**U.S.C.A. Pickens Salley House Renovation
Aiken, South Carolina
OSE Project No. H29-1336
MPS Project No. 10293.00 5-2
January 27, 2012**

ADDENDUM NO. 1

S101 Structural Renovations, Plan Sections, Notes

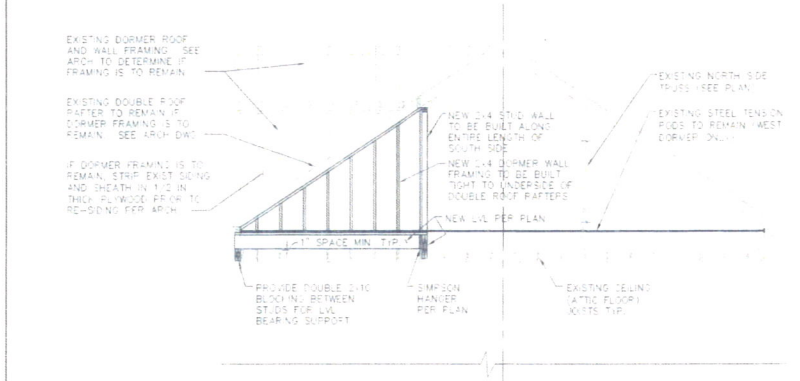
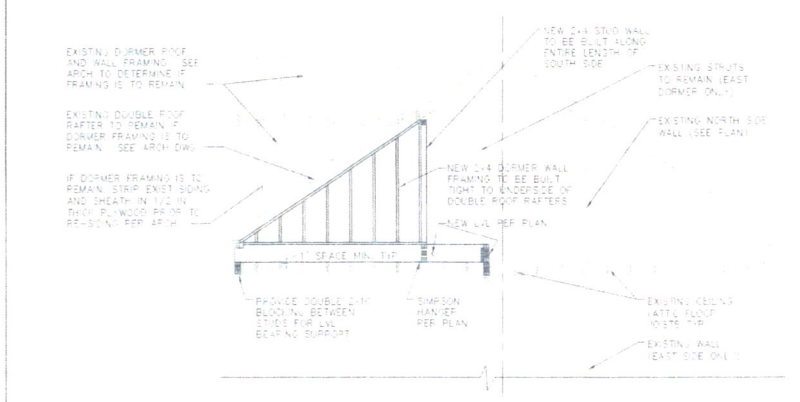
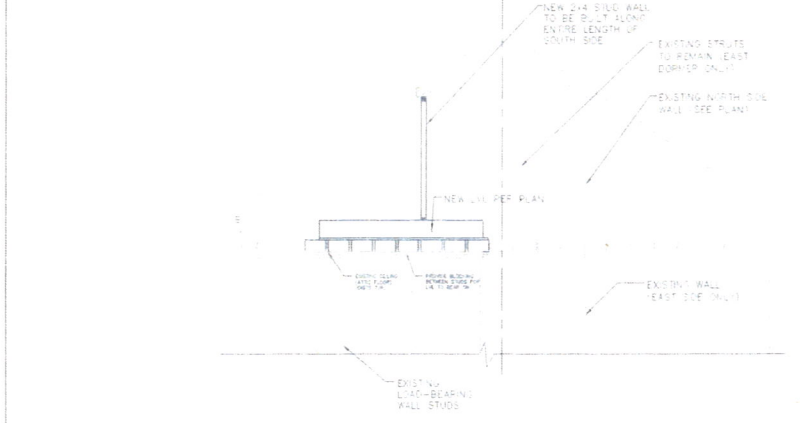
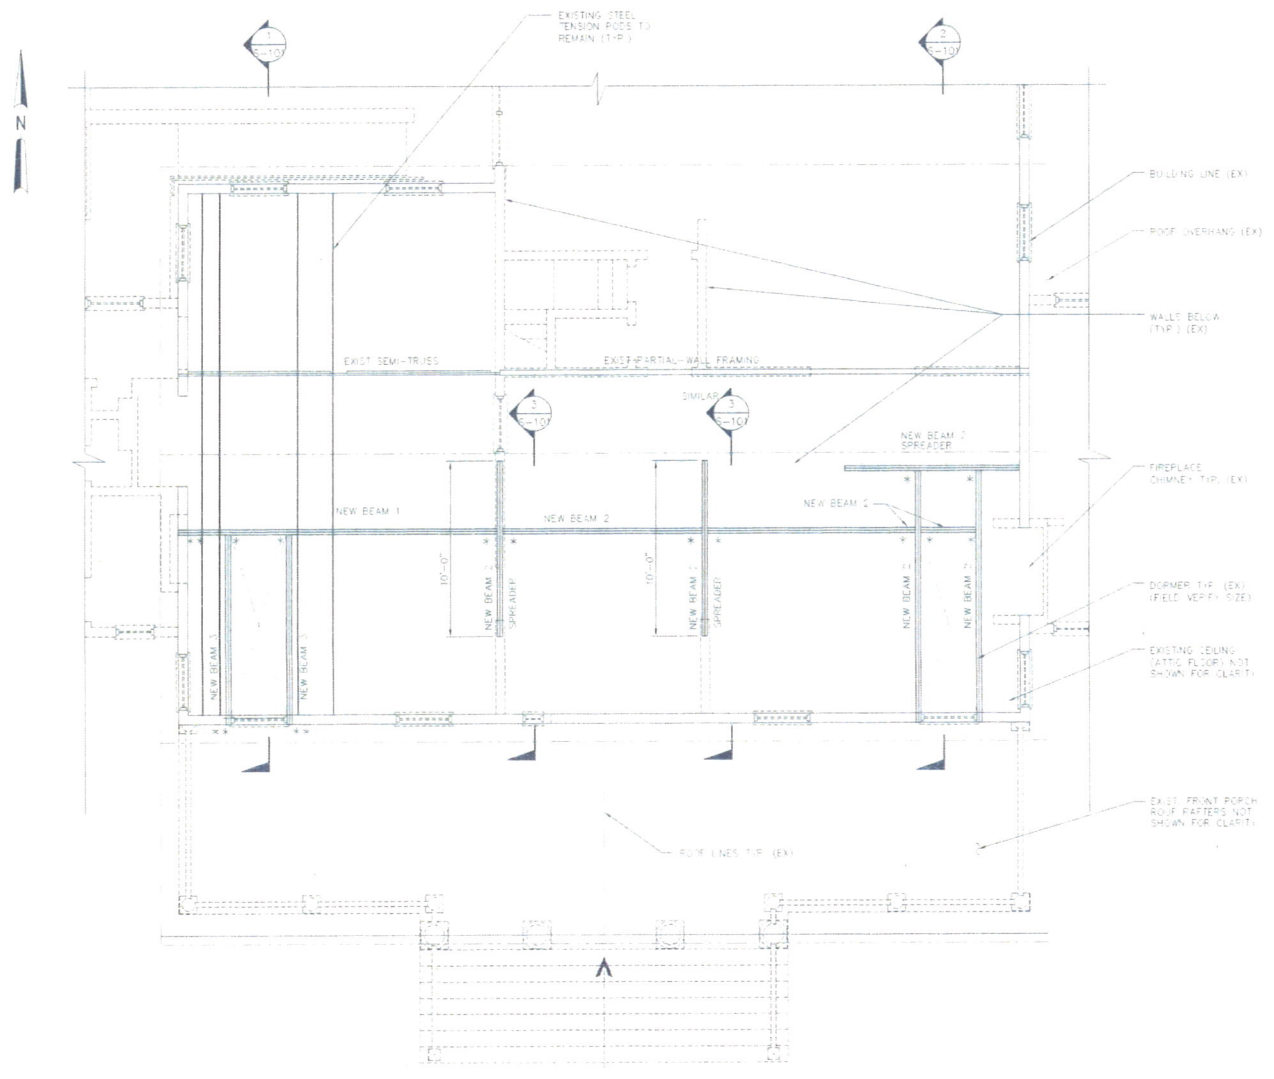
Attached is the S101 sheet noted on the cover sheet and the scope of work outlined on this sheet shall be added to the project.
